BRUNACINI BUILDING

Re: Brunacini Journal Center Tracts A-2-A and A-3-A
Preliminary Grading and Drainage Plan
Engineer's Stamp dated –no stamp- (D17/D003AA7)

Re: Journal Center Office Building, Tracts A2 & A3, ZAP D-17
Preliminary Plan Review

BRUNACINI JOURNAL CENTER
OFFICE BUILDING
TRACTS A2 & A3
9721 RUTLEDGE STREET, N.E.
ALBUQUERQUE, NEW MEXICO

A STORM WATER TREATMENT POND
PLAN VIEW
SCALE 1"=10

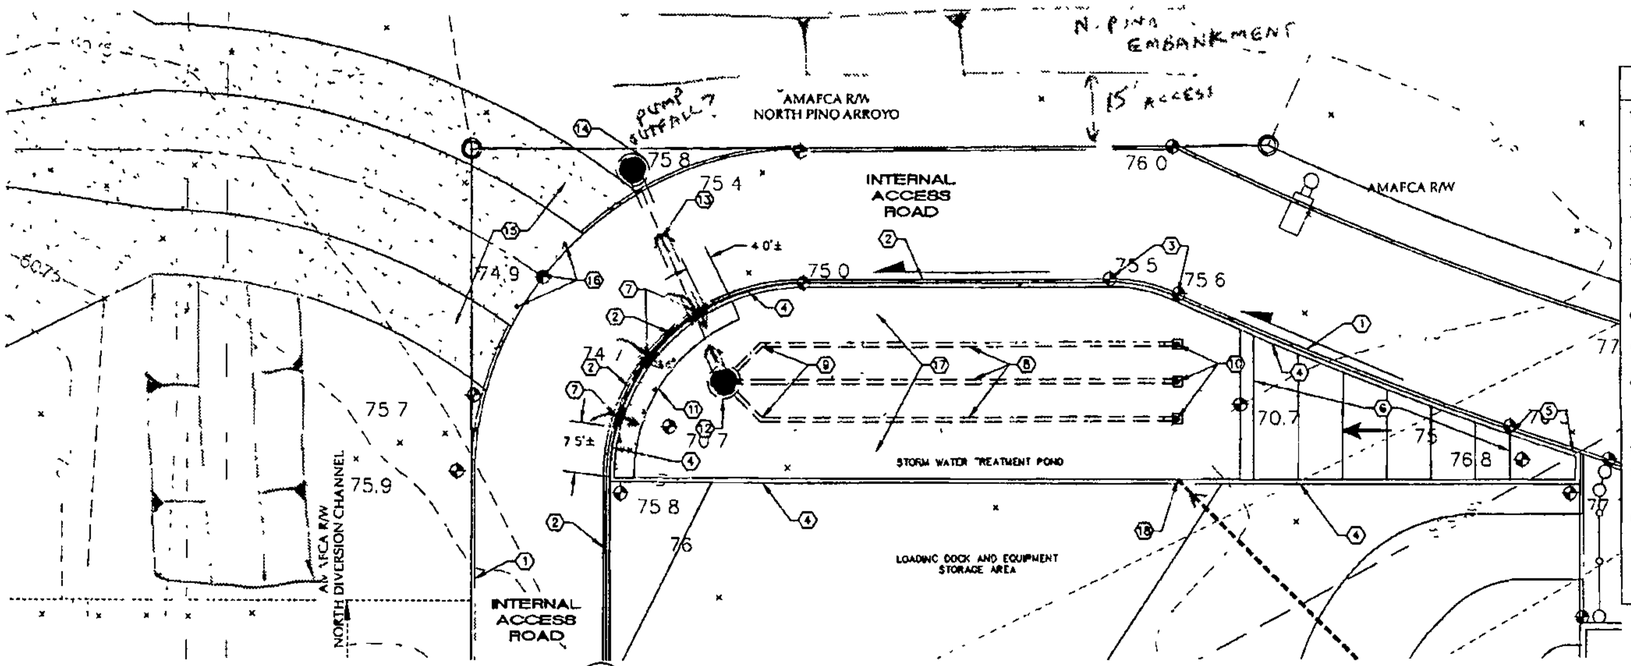
I reviewed the plan with respect to the water quality pond and outfall connection to the North Diversion Channel (NDC). Attached is the detail layout sheet with my mark-ups. I am not ready to approve the preliminary layout; I will need to see the site plan to determine the site drainage pattern. On the detail sheet, it appears that only the loading dock area and the internal access road drain to the water quality pond. The intent of the water quality treatment is to take the first flush rainfall over the entire site through the pond.

WIDE ENOUGH? ANY TRAJECTORY?

"On the detail sheet, it appears that only the loading dock area and the internal access road drain to the water quality pond. The intent of the water quality treatment is to take the first flush rainfall over the entire site through the pond."

· While you are correct that the treatment pond collects all its water from the loading docks and access road, what you couldn't see on that detail sheet is that the access road collects all the offsite water from the east and south. The pond is set up to treat storm water from the entire area.

C POND INLET CURB OPENINGS
PLAN VIEW
SCALE 1"=2

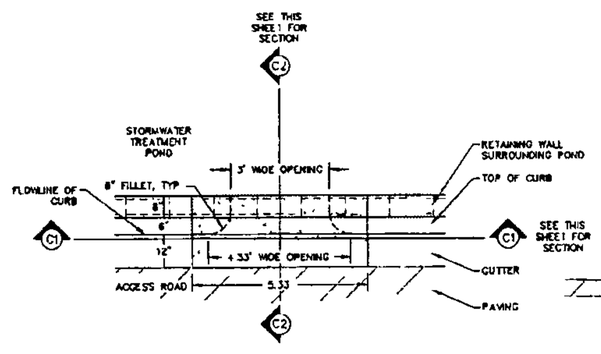
WAS 2' USED TO CALC. FLOW THRU CURB OPENINGS? CAN WE REMOVE TOP OF WALL IN THIS AREA FOR EMERGENCY OVERFLOW?
